RE: Packer Setting Depth Exception

Injection Authority: Division Order No. R-6857
Pool: North Vacuum Abo Pool (Pool code 61760)
North Vacuum Abo West Unit No. 18 (API 30-025-23887)
Unit F, Sec 27, T17S, R34E, NMPM, Lea County, New Mexico

Re: North Vacuum Abo West Unit #18
API# 30-025-23887
Lea County, New Mexico
Request for Exception to Packer Setting Depth

**CURRENT
WELLBORE DIAGRAM**

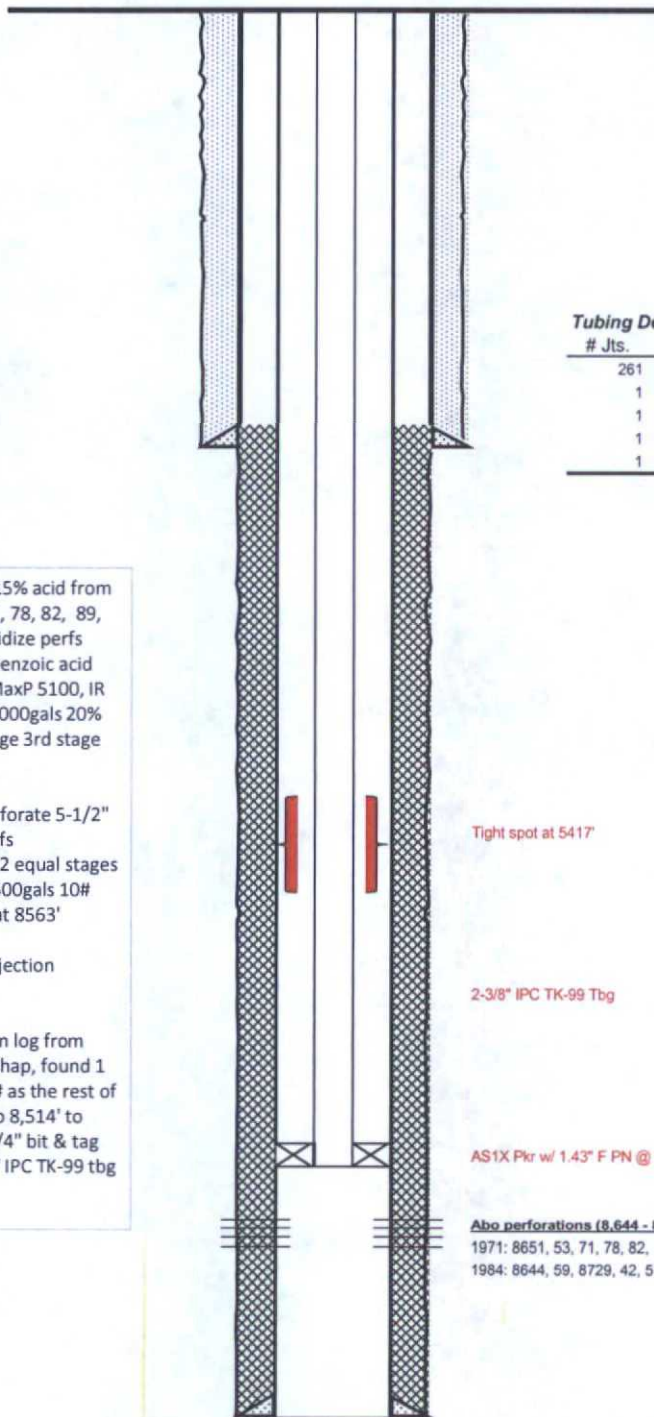
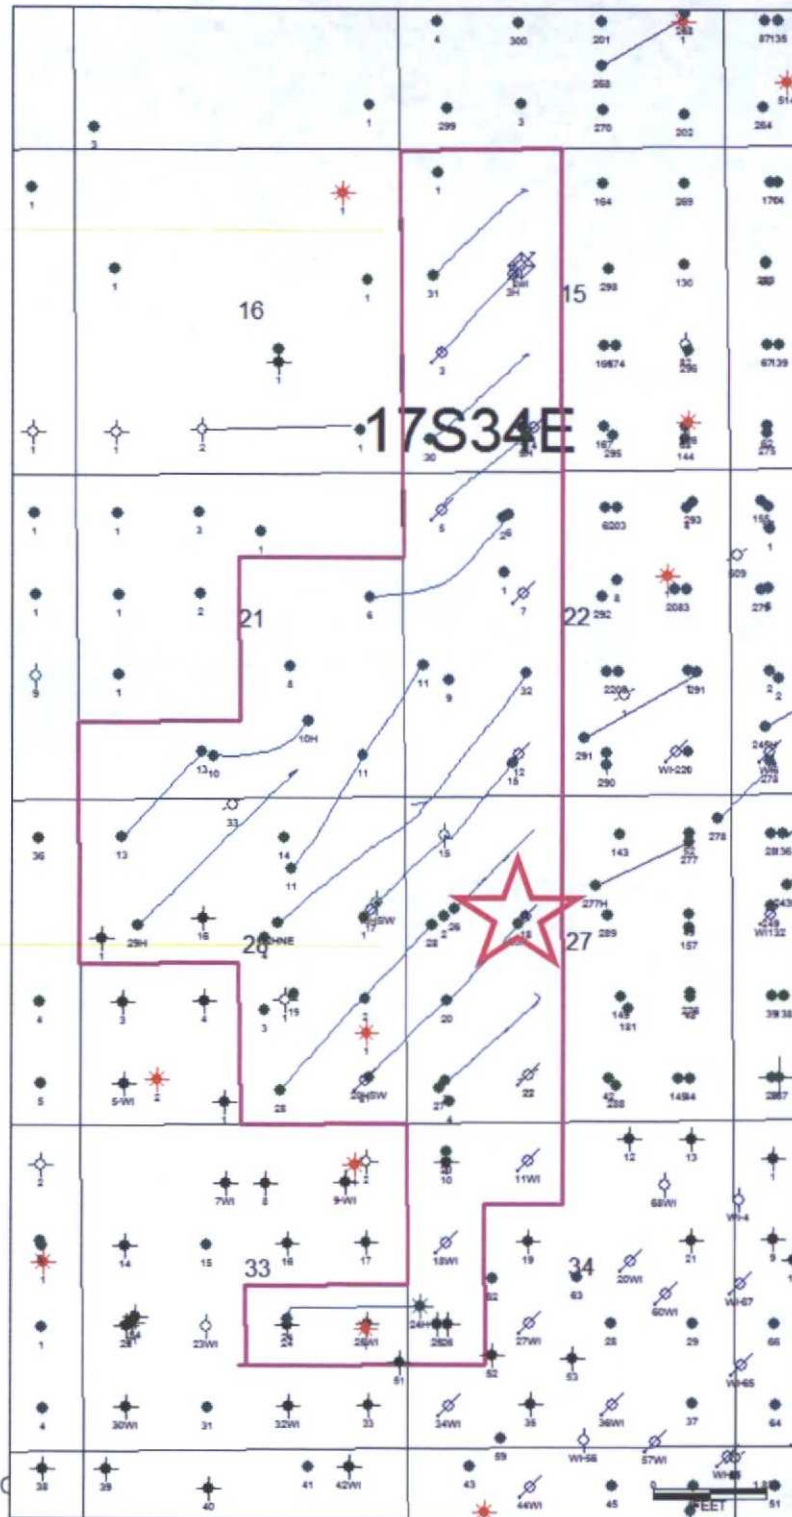
The North Vacuum Abo West Unit (NVAWU) #18 was recently rigged up on from 5/11/16 to 5/18/16 in order to repair a MIT failure. During this repair the packer was set at 8,511', with the top perforation for this well being 8,644', the packer is currently set outside the 100' acceptable window for setting depth. This well is currently 9 months inactive and is still shut-in pending approval from the NMOCD to return the well to injection.

Chevron is requesting that the upper most setting depth for the NVAWU #18 be amended to allow for an acceptable packer setting depth as close to the uppermost injection perforation as possible up to the top of the unitized interval of 8,448'. The top of the Abo formation is at 8,208', and the surrounding wells within a half mile produce out of either the Abo or San Andres formations.

For the reasons stated in the application and because it appears that correlative rights are protected, waste will not occur and this modification will not endanger any fresh water aquifer or the environment, the exception is granted. The packer location within this well shall not be set higher than 133 feet above the current top perforation depth unless the operator receives written approval from the Division Director.
